Re: Draft Cleanup and Abatement Order No. R6V-2015-DRAFT; WDID No. 6B369107001 Requiring Pacific Gas and Electric Company to Clean Up and Abate Waste Discharges of Total and Hexavalent Chromium to the Groundwaters of the Mojave Hydrologic Unit

Attachment A PG&E Comments on Draft Cleanup and Abatement Order

Key Elements of Revised Conceptual Site Model for the Western Portion of the Lower Aquifer, Hinkley, California

Figure 3
Pressure Transducer Data for
Upper Aquifer/Lower Aquifer Well Pairs at MW-23C and MW-92C
 Pacific Gas & Electric Co. Hinkley Compressor Station

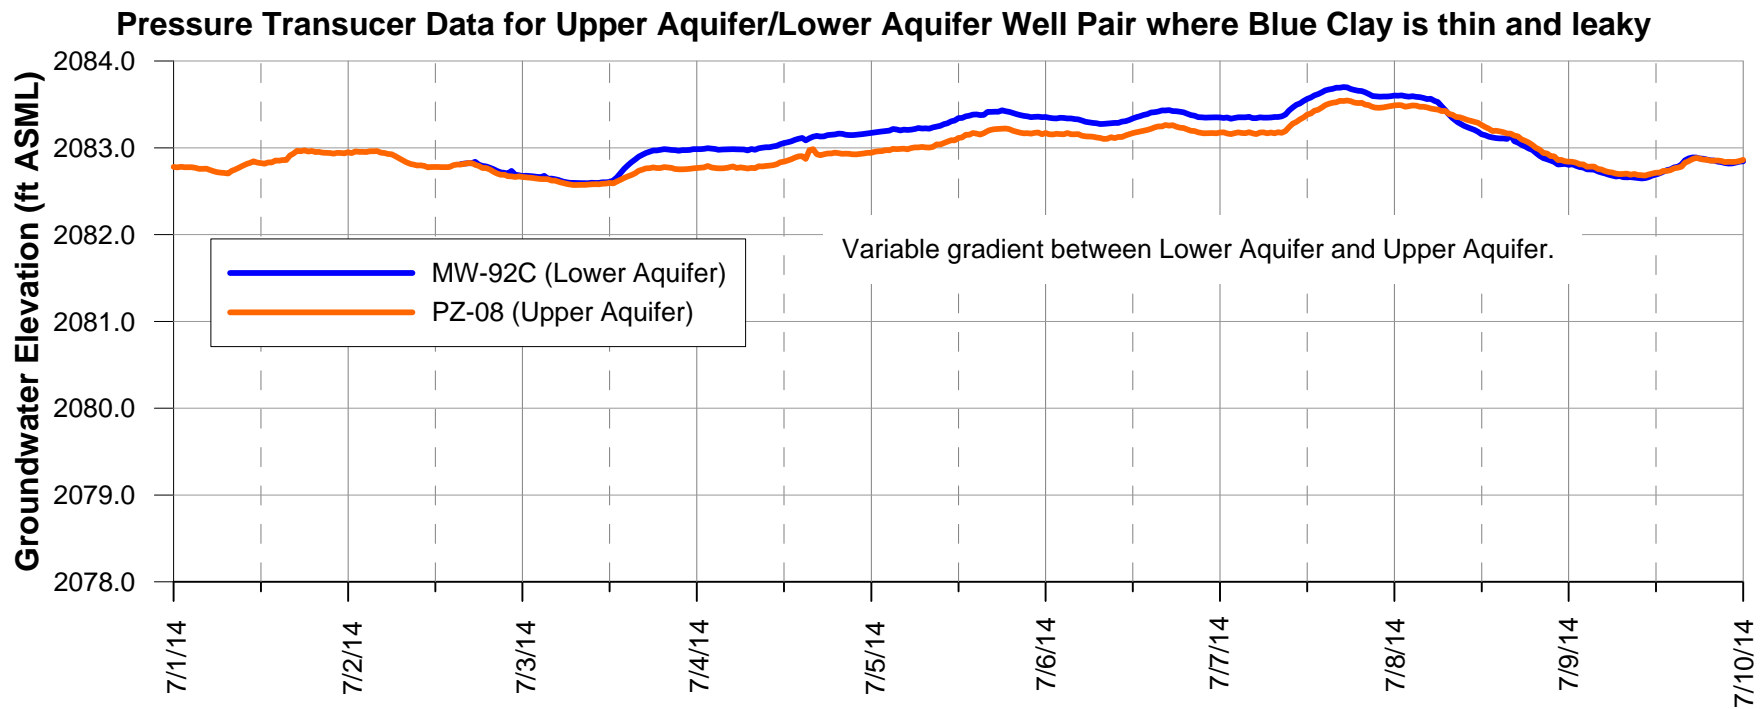
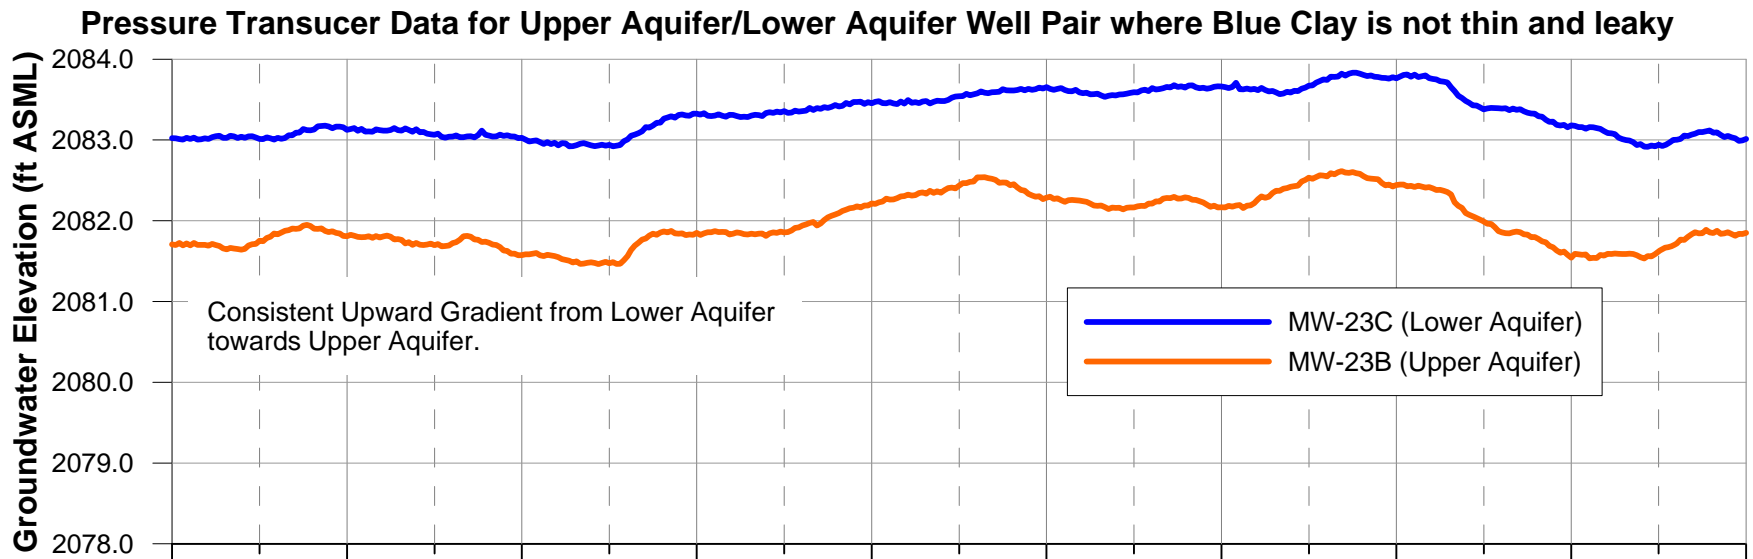
Figure 3 in the attached memo shows hydrographs for upper aquifer/lower aquifer well pairs MW-23B/MW-23C and PZ-08/MW-92C, respectively. The blue clay acts as an aquitard at MW-23C, as demonstrated by the consistently 1-foot higher groundwater elevation at MW-23C than the upper aquifer well MW-23B, demonstrating an upward hydraulic gradient (top panel of Figure 3). On the other

hand, the hydrograph for the PZ-08/MW-92C well pair shows comparable groundwater levels at both the upper and lower aquifer wells without a significant vertical gradient like the MW-23B/23C hydrograph (bottom panel Figure 3). The hydrograph for PZ-08/MW-92C is corroborated by the observation of thin and sandy blue clay in this area and suggests that the blue clay does not act as an aquitard in this area. Figure 4 shows hydrographs for upper aquifer/lower aquifer well pairs MW-42B2/MW-42C and PZ-09/MW-100C, respectively. Like the MW-23B/MW-23C hydrograph, lower aquifer well MW-42C shows a consistently higher groundwater level (more than 1.5 feet) than upper aquifer well MW-42B2, indicating that the blue clay acts as an aquitard in this area. While an upward gradient is shown in the hydrograph for PZ-09/MW-100C (blue line above orange line), both wells respond equally to changes in upper aquifer groundwater extraction at upper aquifer extraction well EX-26, indicating that the blue clay does not act as an aquitard in this area.

Figure 3 shows hydrographs for Upper and Lower Aquifer well pairs MW-23B/MW-23C and PZ-08/MW-92C, respectively. The blue clay acts as an aquitard at MW-23C, as demonstrated by the consistently 1-foot higher groundwater elevation at MW-23C than the Upper Aquifer well MW-23B, demonstrating an upward hydraulic gradient (top panel of Figure 3). On the other hand, the hydrograph for the PZ-08/MW-92C well pair shows comparable groundwater levels at both the Upper and Lower Aquifer wells without a significant vertical gradient like the MW-23B/23C hydrograph (bottom panel Figure 3). The hydrograph for PZ-08/MW-92C is corroborated by the observation of thin and sandy blue clay in this area and suggests that the blue clay does not act as an aquitard in this area. Figure 4 shows hydrographs for Upper and Lower Aquifer well pairs MW-42B2/MW-42C and PZ-09/MW-100C, respectively. Like the MW-23B/MW-23C hydrograph, Lower Aquifer well MW-42C shows a consistently higher groundwater level (more than 1.5 feet) than Upper Aquifer well MW-42B2, indicating that the blue clay acts as an aquitard in this area. While an upward gradient is shown in the hydrograph for PZ-09/MW-100C (blue line above orange line), both wells respond equally to changes in Upper Aquifer groundwater extraction at Upper Aquifer extraction well EX-26, again indicating that the blue clay does not act as an aquitard in this area.
